Application to Change PDA Development Approval - NEXTDC Sunshine Coast (SC2), 10 South Sea Islander Way, Maroochydore (EDQ Ref: DEV2025/1604)

The proposed amendment comprises minor modifications to the approved design in response to construction and detailed design requirements. The modifications include adjustments to the configuration of the ramp and stair entry, external terrace, screening and façade details.

Table 1: Comparison of approved ramp and stair design and proposed design

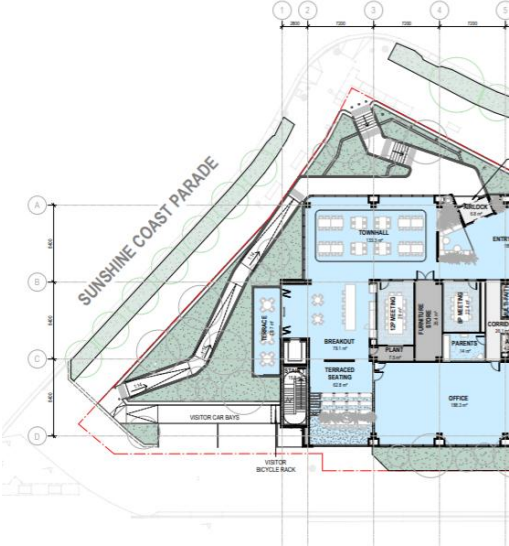
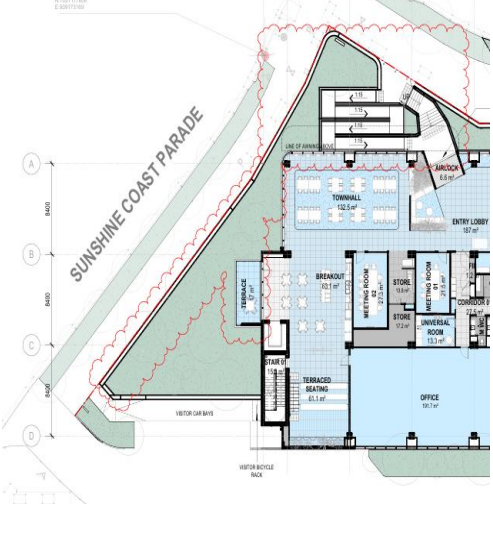
1. Revised ramp and stair to the entry

Following further design investigations, it is proposed to reconfigure the DDA ramping that was introduced into the design on the Sunshine Coast Parade frontage. Instead of running the ramp across the full length of the frontage (which wasn't seen as the optimum outcome at the time), a solution has been developed to contain the ramp within South Sea Islander Way frontage, adjacent to the main entrance, coupled with an adjustment to the stairs. This has the added benefit of providing an additional 49 sq m of landscaped area. Please see plans and images below in **Table 1**, extracted from the plans to illustrate and compare the proposed modifications.

Approved Design	Revised Design
 Ramp along Sunshine Coast Parade Frontage	 Ramp reduced to South Sea Islander Way frontage.
 View of Sunshine Coast Parade frontage with ramp	 View of Sunshine Coast Parade frontage without ramp

Table 2: Comparison of approved and proposed external terrace

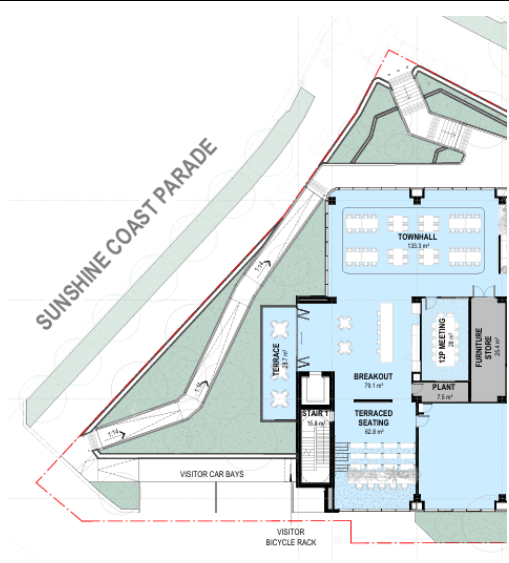
2. Reduced External Terrace

As show in **Table 2** below, the external terrace to the southern façade is proposed to be marginally reduced in size from 28.7m² to 17m².

Approved Design	Revised Design
 Approved external terrace	 Proposed external terrace
